Safety Advice

GreenMech Woodchippers

Ref: NRA23-09

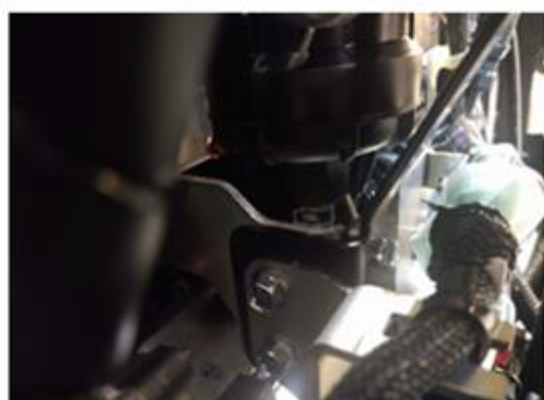
A number of GreenMech Woodchippers, EVO 205D SAFE and SURE-Trak models have left the factory without the Engine Harness Support Bracket being fitted.

GreenMech have now created a new bracket for retrofit, along with a new Over Centre Valve Mount which needs to be fitted in order to accommodate the new bracket and revised wiring loom position.

Harness

New position of over centre valve

Bracket

Old position of over centre valve

1. Inspect EVO 205D SAFE and SURE-Trak models and confirm if retrofit work needs to be undertaken.
2. If work needs to be undertaken, parts should be ordered under:
 - ▶ Engine Harness Support Bracket – 4038913
 - ▶ Track Leg, Over Centre Valve Mount - 4038922
3. Any issues or questions should be directed to Service Department support@greenmech.co.uk or 01789 400044 Option 2.
